31/7-90P 9915 Capitol View Avenue
Capitol View Park

SUBJECT: Historic Area Work Permit Application No. 9008280061

HISTORIC PRESERVATION COMMISSION STAFF REPORT

SITE/DISTRICT NAME: Capitol View Park PROPERTY ADDRESS: 9915 Capitol View Avenue

SITE PLAN

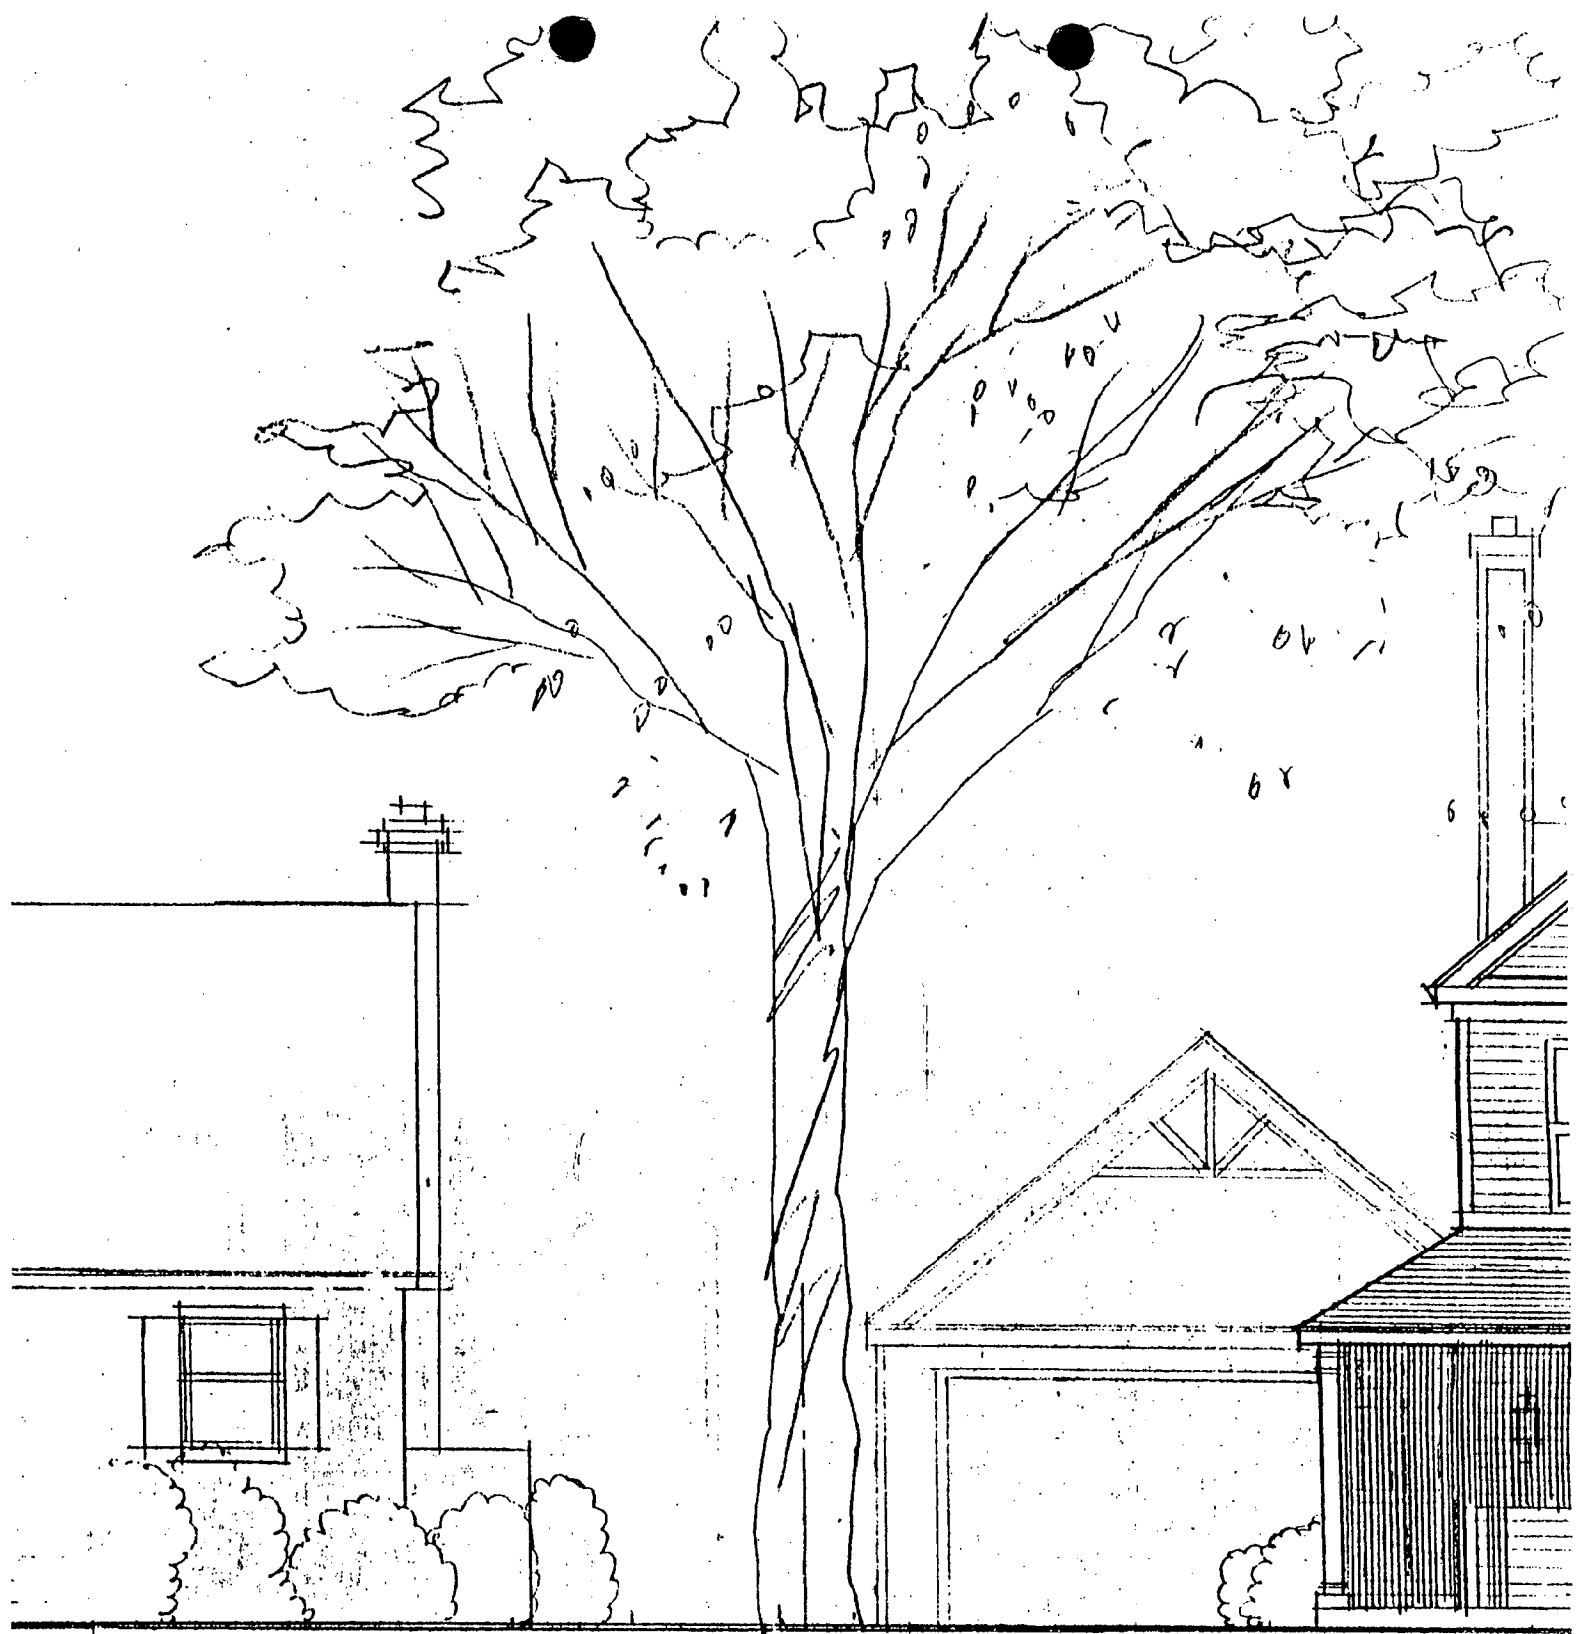
The applicant is proposing to construct a two-story house in the neo-Victorian style and a detached two-bay garage to the rear of the property. The proposed house would measure 30' in width, including a 4' wide wrap-around porch, and would be set back 50' from the front property line. Side setbacks are 15' on the driveway side, 5' on the opposite side. The driveway leading to the rear garage is approximately 8' wide.

- ° The proposed house with attached garage is not in scale with adjacent houses. The structure appears too wide and is a two story structure in an area of predominantly one story and one and one-half story Bungalows. The side yards would decrease the usual amount of space between houses and would visually impinge on the adjacent houses. It was suggested that the garage be eliminated from the plan or that it be detached and moved to the rear of the lot. It was also suggested that the total width of the structure be reduced to a width comparable to adjacent homes.

- ° Construction of the garage in the location as proposed would include a portion being built under the drip-line of a large tree on the side of the property. Construction of impervious materials over the tree root system could be harmful to the tree and possibly cause the tree to die.

The applicant has responded to a few of the Commission's comments with the proposal presently submitted by reducing the width of the house and proposing a detached garage located to the rear of the property. However, in doing so, the house has been moved forward 15' towards the front property line and is no longer located with a setback equal to the houses on either side of it, making it incompatible with the existing streetscape. In addition, while the width of the house has been reduced, its height remains at two stories and still would appear out of scale to adjacent houses.

Staff recommends denial of the application based on criterion 24A-8(a). The new house, as proposed, does not appear compatible to the overall scale or rhythm of the existing streetscape. However, if the applicant is willing to revise the plans to incorporate a setback uniform with adjacent homes and to reduce the apparent height of the house to one and one half stories (by using a gambrel or mansard type of roof, for example), staff would recommend that the record be left open for review of these revisions.

FRONT ELEVATION

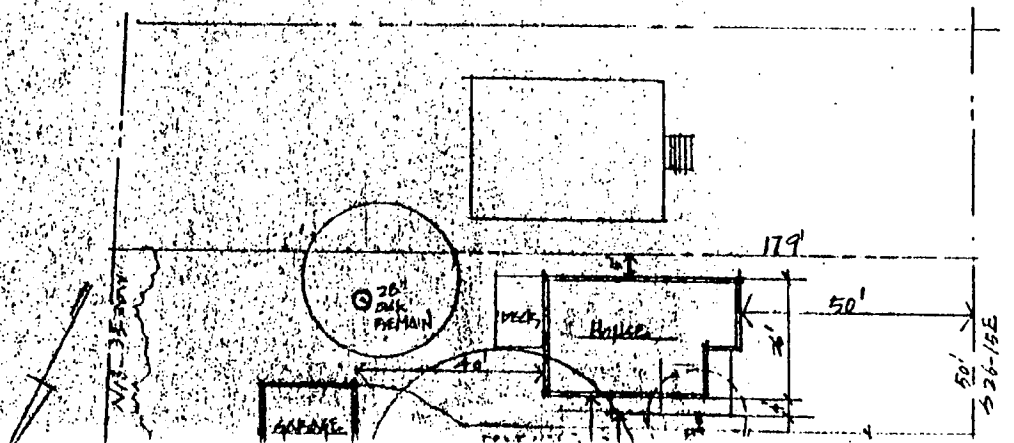
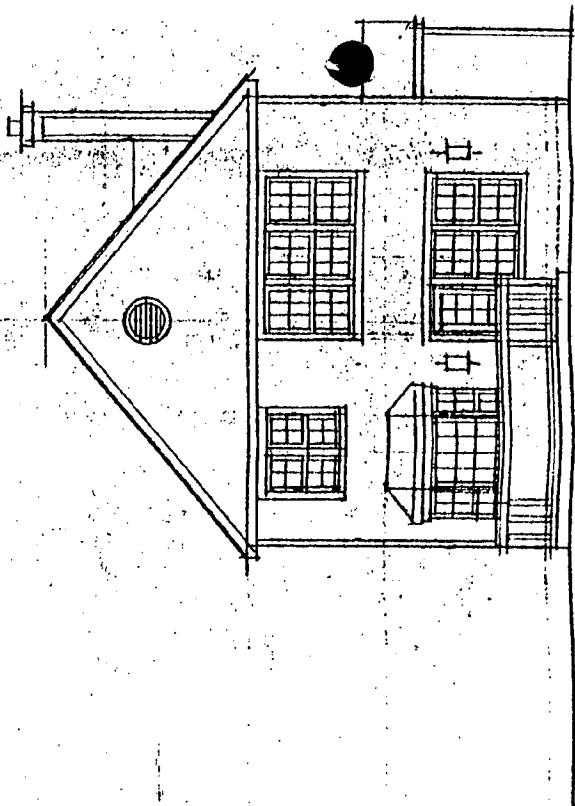
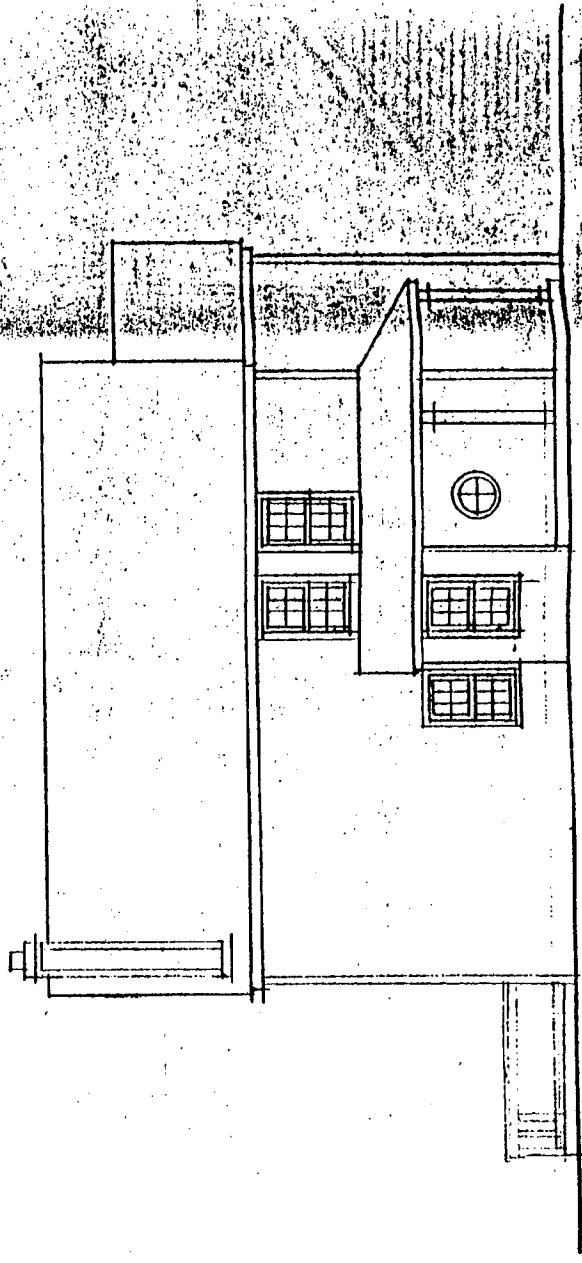
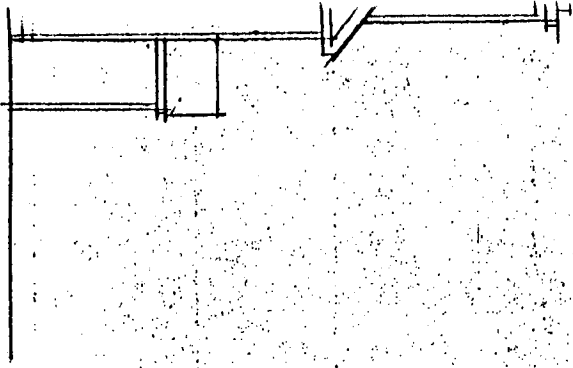
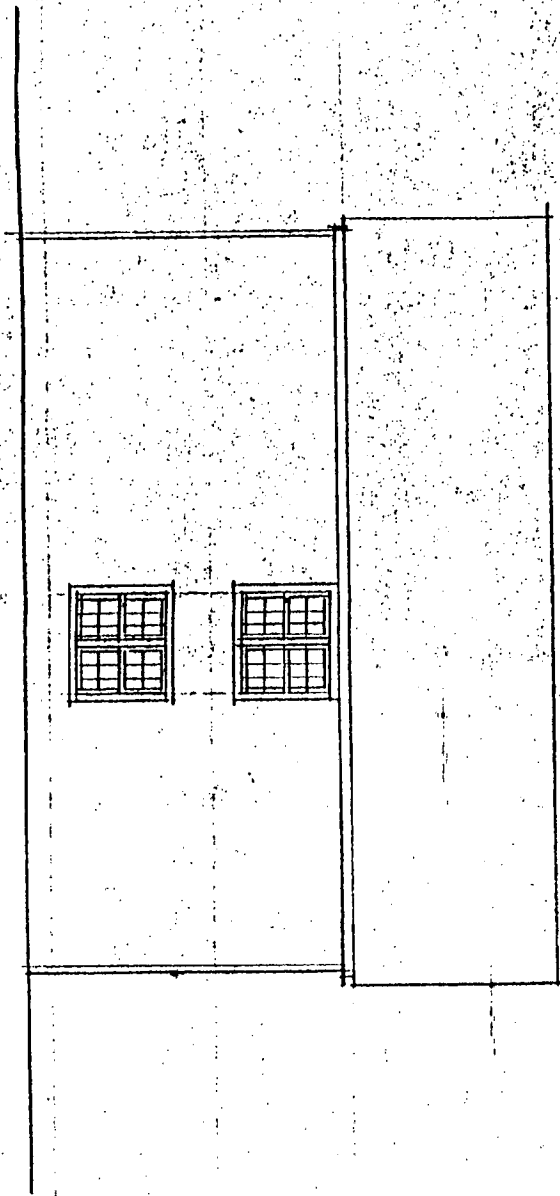
The LAP is absolutely opposed to approval of this application as pending. The proposed houses are 2 1/2 - 3 stories in a street scape of cozy 1 - 1 1/2 story bungalows, along both sides of Capitol View Avenue. The proposed construction has a height and massing that is inconsistent with and contrary to the surrounding homes.

1. The proposed house should be built at a setback equal to adjacent houses. You may want to work with an arborist to determine an appropriate foundation material to be used so that the structure does not interfere with the drip line of a large tree on the north side of the property.
2. The height of the proposed structure, coupled with the proposed roof style, makes the proposed structure appear out of scale with adjacent houses and would interrupt the rhythm of the streetscape. The Commission recommends you consider altering the roof style on the house to so that the "apparent" height is no more than one and one-half stories.

SITE PLAN

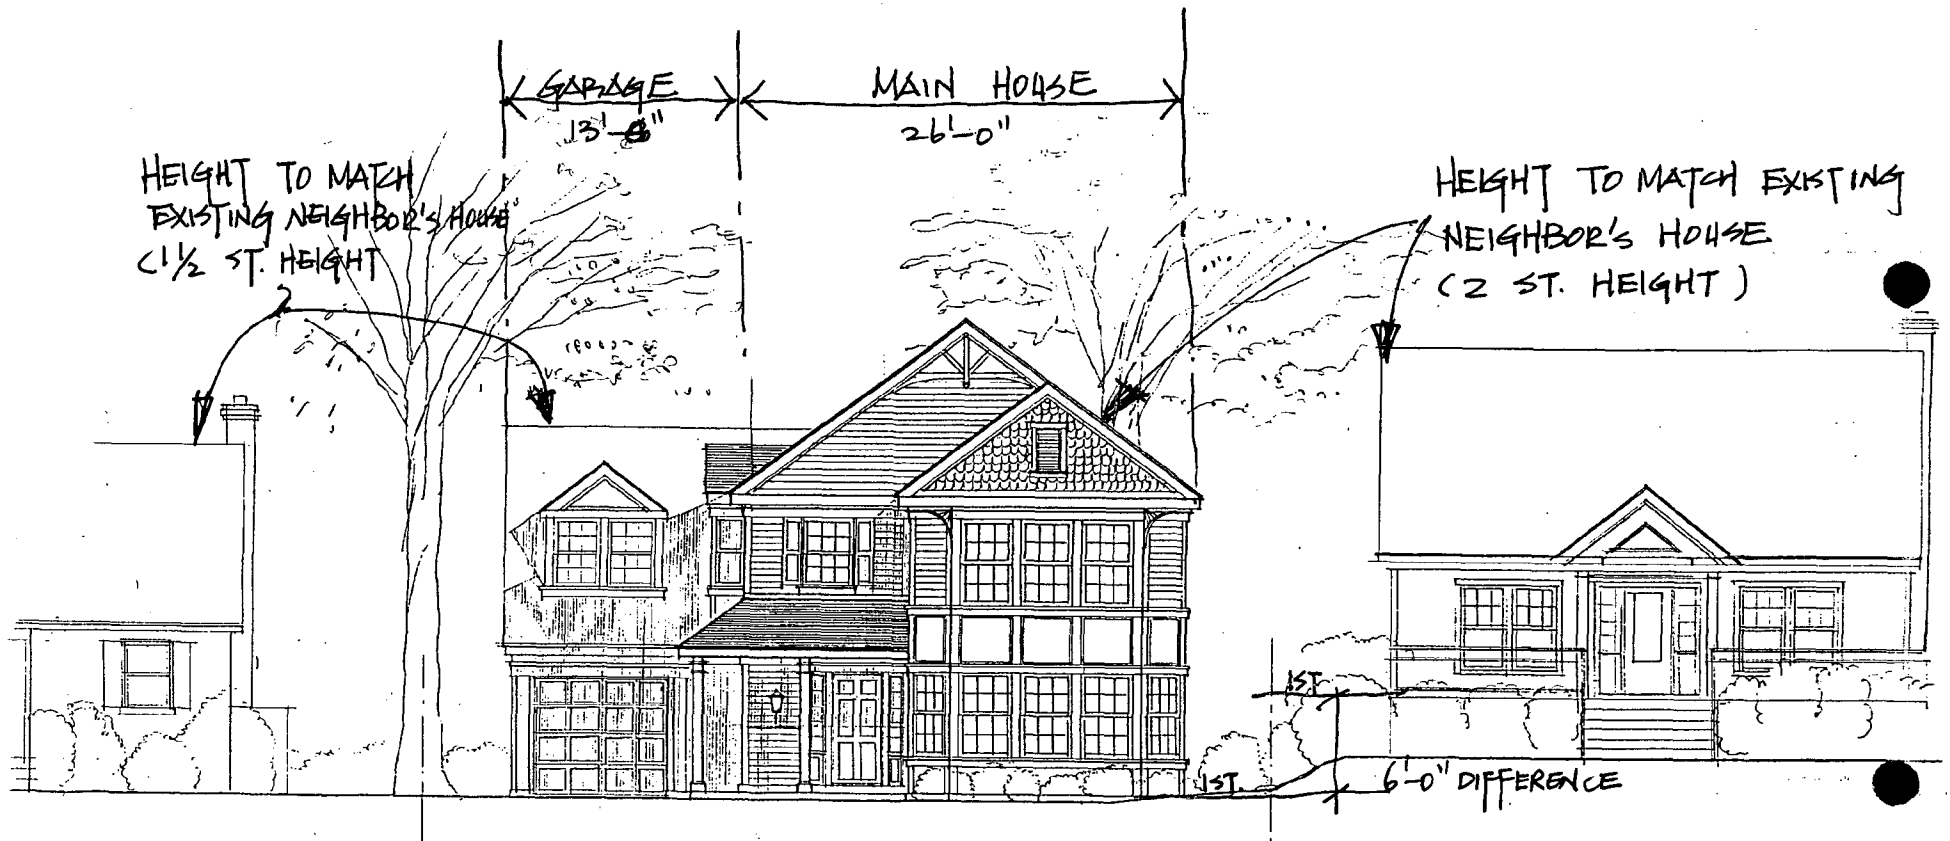
- Construction of the garage in the location as proposed would include a portion being built under the drip-line of a large tree on the side of the property. Construction of impervious materials over the tree root system could be harmful to the tree and possibly cause the tree to die.

The applicant met with staff for a preliminary consultation earlier this year. At that time, the applicant and staff discussed a standard house plan which consisted of a two-story structure, approximately 38' wide and with a garage facing the street. Staff made several comments based on consideration of existing adjacent structures and the overall streetscape. First, it was suggested that the width of the house was oversized for the lot and in comparison with adjacent houses. It was recommended that the overall width of the structure be reduced to approximately 30' and that the floor plan be changed to one that was more linear (front to back instead of side to side) in order to somewhat alleviate massing concerns without losing the square footage desired by the applicant. Second, staff recommended that the garage be moved to the back of the house or that a side entrance be utilized. Finally, staff suggested that the overall height of the structure be reduced to appear more compatible with the homes on either side.

The applicant has partially responded to staff's comments with the present plan submitted in that the garage is set back from the front elevation. The height and width of the proposed structure, however, is still greater than the immediately adjacent structures and renders the structure incompatible with the existing streetscape. Staff recommends that the applicant make further revisions to the overall scale and massing of the proposed house to respond to these concerns and any others raised by the Commission before submitting a formal HAWP application.

FRONT ELEVATION

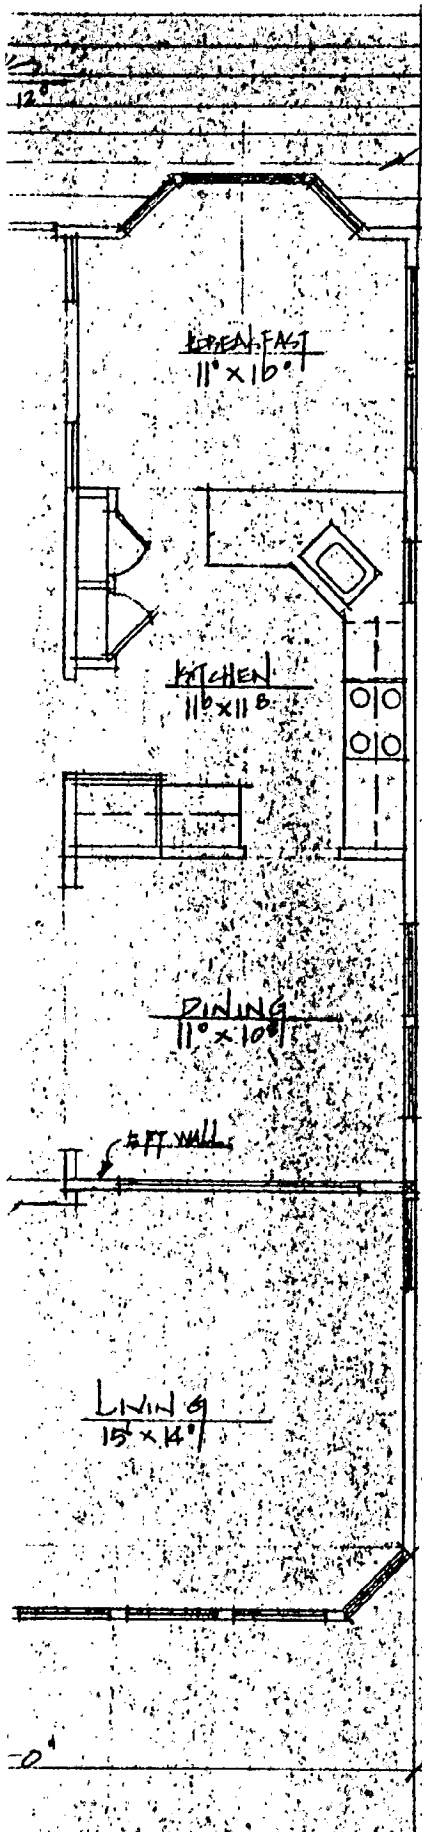
- The proposed house with attached garage is not in scale with adjacent houses. The structure appears too wide and is a two story structure in an area of predominantly one story and one and one-half story Bungalows. The side yards would decrease the usual amount of space between houses and would visually impinge on the adjacent houses. It was suggested that the garage be eliminated from the plan or that it be detached and moved to the rear of the lot. It was also suggested that the total width of the structure be reduced to a width comparable to adjacent homes.

- The Victorian style and fenestration as proposed is not necessarily a primary style in the Capitol View Park historic district. Other styles could also be considered, including Bungalow, American Four-Square, Craftsman, etc.
